PROJECT  
CITY OF PORT PHILLIP  
CONDITION AUDITS  
17 Eildon Road,  
ST KILDA, VIC, 3183  
PROJECT NUMBER  
1614

Architecture & Access has been commissioned to provide access consulting services for City of Port Phillip, for the proposed works at a child care centre at 17 Eildon Road, St Kilda.

The purpose of this report is to provide the client and design team with an access evaluation of the proposed plans. The report will provide comment on and advice regarding elements within the design that may leave the building owner, tenants or the design team exposed to a potential claim under the Disability Discrimination Act (DDA).

FS03.1A

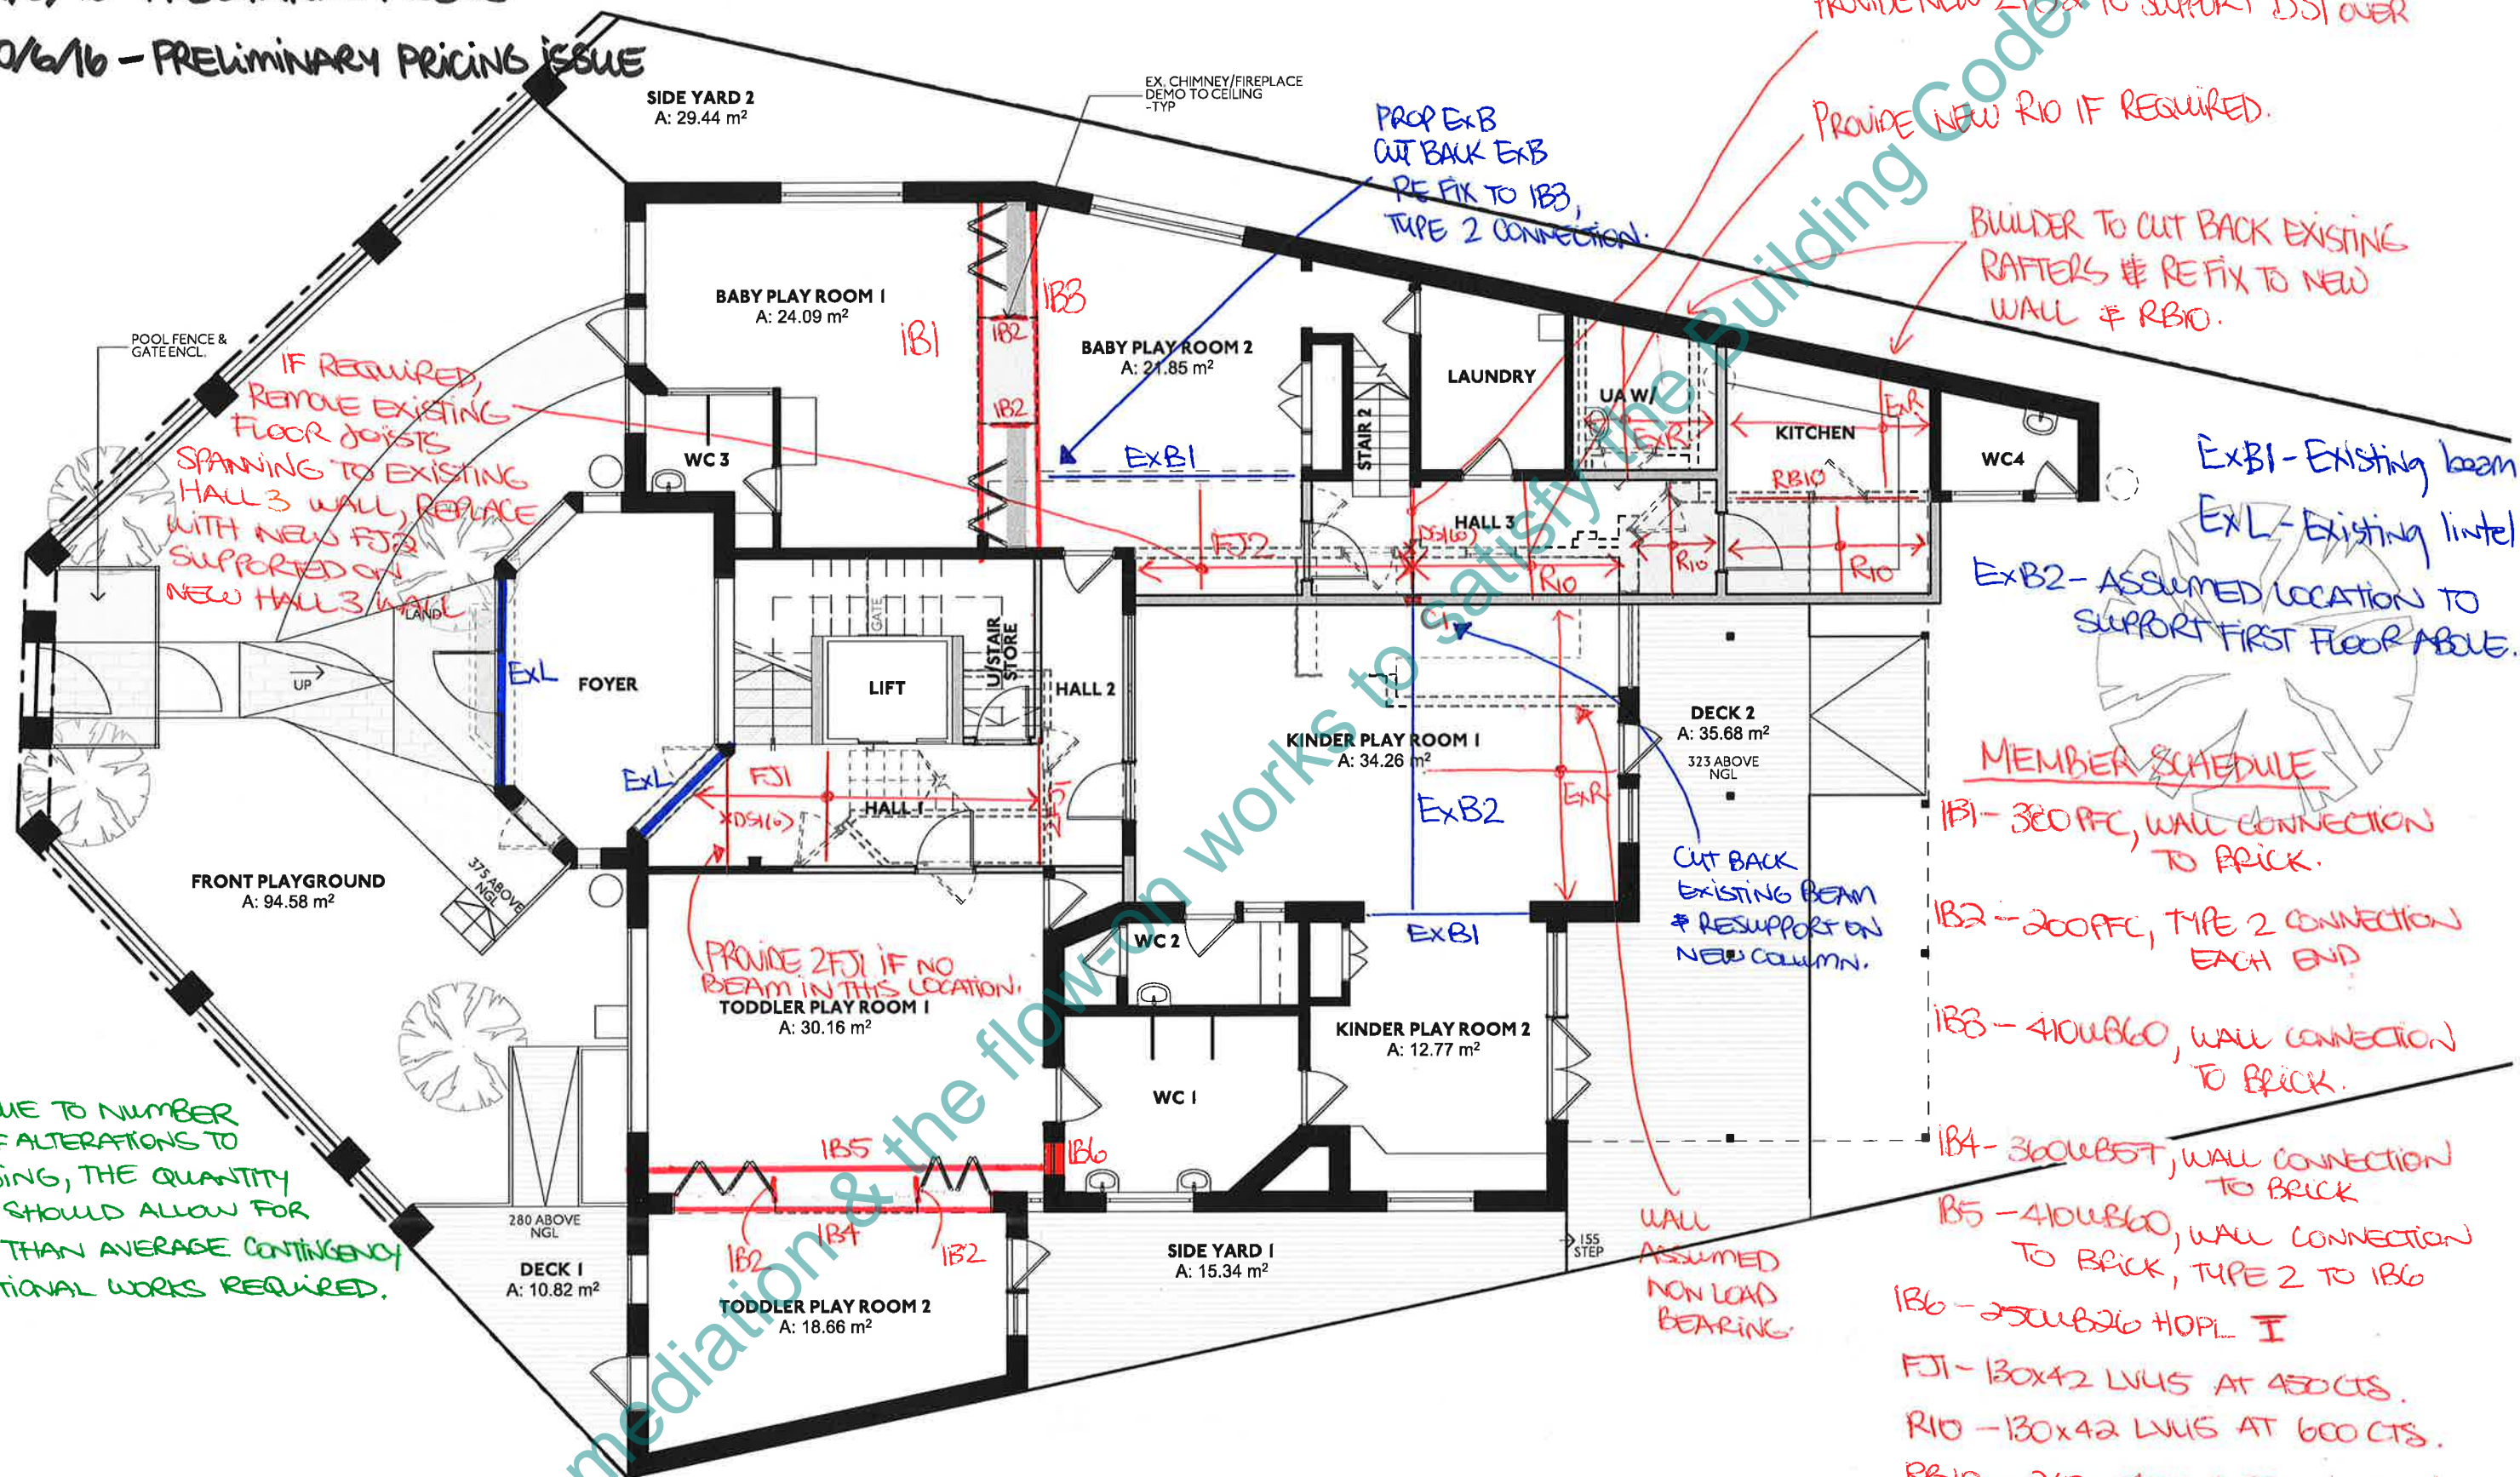
2.1	External Paths of Travel		
	Issue	Action	Rating
.1	As a door handle height higher than 1100mm AFFL is required for security at all entry points, independent access will not be possible.	A management plan will be required (including via an intercom at main entry) so that staff can provide assistance.	X 
.2	Clear opening width of gates is scaling approx 1000mm which is acceptable.	Provide note/dimensions on drawings stating that clear opening width is min 850mm.	R 
.3	Entry gate airlock. Distance between arc of entry gate 1 & opposite gate is scaling 700mm.	Provide min 1450mm in an airlock between doors & arc of any swing door (AS 1428.1 Clause 13.4).	H 
.4	Landings at gates are too narrow to provide compliant latchside clearance.	As staff will be providing assistance (refer item above), compliant latchside clearance is not required.	X 
.5	Gradient of entry path. No details at this stage.	Provide a gradient & crossfall no steeper than 1:40 to entry path/gate landings.	H

<b>3.1</b>	<b>Entrances</b>		
	<b>Issue</b>	<b>Action</b>	<b>Rating</b>
.1	External landing depth is scaling 1550mm, and latchside clearance of 530mm is provided.	Monitor as documentation progresses to ensure landing size of min 1450 mm deep is provided.	
.2	Thresholds. No details.	Provide level thresholds or threshold ramps in compliance with AS1428.1.	H 
.3	Force to open. No details of door closer.	Force to open to be 20N max or auto door required. Door specifier to confirm compliant forces will be achieved.	H

<b>4.1</b>	<b>Doors - General Comments</b>		
	<b>Issue</b>	<b>Action</b>	<b>Rating</b>
.1	Doors generally. Clear opening width scales as being non-compliant.	Provide 850mm min clear open width to all doors except WC 2, Laundry & store rooms.	H 
.2	Luminance contrast of doors is unknown at this stage.	As documentation progresses, confirm door, wall and/or frame colours provide a minimum luminance contrast of 30% between two of these surfaces.	H 
<b>4.2</b>	<b>Doors - Ground Floor Level</b>		
	<b>Issue</b>	<b>Action</b>	<b>Rating</b>
.3	Pair of doors to Kinder Playroom 2 are scaling only 1500mm overall.	Provide min 850mm clear opening width through the active leaf.	H 
.4	Folding doors to Toddler & Baby Play rooms. These doors may be difficult to operate with one hand.	It is presumed that staff will operate these doors. Provide a swing door. Building Surveyor to confirm.	H 
.5	Door from Toddler Play Room 2 to Side Yard 2 has a non-compliant latchside clearance.	Provide min 510mm latchside clearance internally & 530mm externally. Hinge the door on the opposite side.	H

.6	Door from Toddler Play Room 2 to Deck 1 has a non-compliant landing depth externally.	Provide min 1670 mm deep landing depth for the full width of the door plus 110 mm hinge side & 900mm latchside for side on approach.	H 
.7	Door from Hall 3 to Kitchen is scaling as having compliant latchside clearance.	Provide dimensions on drawings to ensure 510mm latchside clearance is achieved.	R

.8	Door from Hall 3 to Baby Play Room 2. Latchside landing depth is impeded by Stairway.	Provide 1450mm landing depth at the door including for the width of the 530 mm latchside.	H 
.9	Door to Baby Play Room 2 has a non-compliant latchside clearance in Hall 2.	Provide 530mm latchside clearance.	H 
.10	External door from Baby Play Room 1 to Front Playground is likely to have a non-compliant threshold due to ground level/ floor level difference.	Review levels at threshold. Provide details for review.	H 
.11	External landing at Baby Play Room 1 is non-compliant.	Provide paved landing min 1450 mm deep for the full width of the door plus 110 hinge side & 530 mm latchside.	H

7.1	Internal Paths of Travel		
	Issue	Action	Rating
.1	Stairs appear to impede access to Office on first floor level.	Review layout.	H 
.2	There is not enough space for a wheelchair to turn around at end of Hall 2 (at GF & at FF Levels).	Provide 1540 wide x 2070 mm turning space within 2m of the end of path of travel where it is not possible to continue.	H

8.1	Walkways & Ramps - General Comments		
	Issue	Action	Rating
.1	Limited details of ramps.	Refer requirements and recommendations outlined in Reference 8.0. Provide further details for review.	H 
.2	Handrails & kerbrails to 1:14 ramp. None provided.	Provide handrails on both sides of the ramp in accordance with AS 1428:2009 - refer	H

attached requirements & recommendations in Reference Notes 8.	
.3	TGSIs are not indicated.	Provide TGSIs at top and base of 1:14 ramp, across the full width & in a colour which provides a compliant luminance contrast. Set back TGSIs 300mm from the top and base of the ramp for a depth of 600-800mm.	H 
<b>8.2</b>	<b>External Entry Ramp</b>		
	<b>Issue</b>	<b>Action</b>	<b>Rating</b>
.4	No details of ground/floor levels or ramp gradient have been provided.	Provide compliant gradient of max. 1:14.	H 
.5	Landing size. Compliant landings may not be possible once gate airlock depth is increased (see earlier item re: gates).	Provide min 1200mm long landings at top & base of ramp. Review ramp layout.	H 
<b>8.3</b>	<b>External Ramps to Decks 1 &amp; 2</b>		
	<b>Issue</b>	<b>Action</b>	<b>Rating</b>
.6	Ramp to Deck 1 has a rise of 280mm and is scaling as being 2500mm long. It is too steep.	Provide a ramp min 3920mm long to achieve a compliant gradient no steeper than 1:14.	H

.7	Ramp to Deck 2 has a rise of 323 mm and is scaling as being 1800mm long. It is too steep.	Provide a ramp min 4522 mm long to achieve a compliant gradient no steeper than 1:14.	H 
.8	Handrails & kerbrails to ramps (with gradient 1:14). None provided.	Provide handrails on both sides of the ramp in accordance with AS 1428:2009 - refer attached Reference Notes.	H

10.1	Lift		
	Issue	Action	Rating
.1	Limited details of lifts.	Refer requirements and recommendations outlined in Reference 10.0. Provide further details for review.	H 
.2	Lift car size is scaling as 1800 wide x 1500 mm deep. It is not clear if this will be finished dimensions.	Provide lift size of min 1100x1400mm clear finished dimensions.	H

11.1	Unisex Accessible WC (UAWC)		
	Issue	Action	Rating
.1	A UAWC facility is provided on both levels of the building, however no details yet on the layout of each WC.	Provide equal numbers of right and left handed configurations.	H 
.2	A shower appears to be located in WC2. The circulation to and within the shower area is restricted.	It is recommended that a larger circulation area is provided to assist staff when undertaking the safe washing of children.	R 
.3	GF UAWC. Compliant circulation space cannot be achieved in this room size.	Review room size. Provide WC circulation space of min 1900x2300mm.	H 
.4	Rear wall of GF UAWC is not perpendicular to side walls. Compliant grab rail locations will be difficult to achieve.	Review room shape to provide compliant grab rail locations in accordance with AS 1428.1:2009 Clause 15.2.7 & Figure 42.	H 
.5	FF UAWC. Room size is scaling 2600 x 2600mm.	A compliant layout can be achieved if provided in accordance with AS 1428.1:2009.
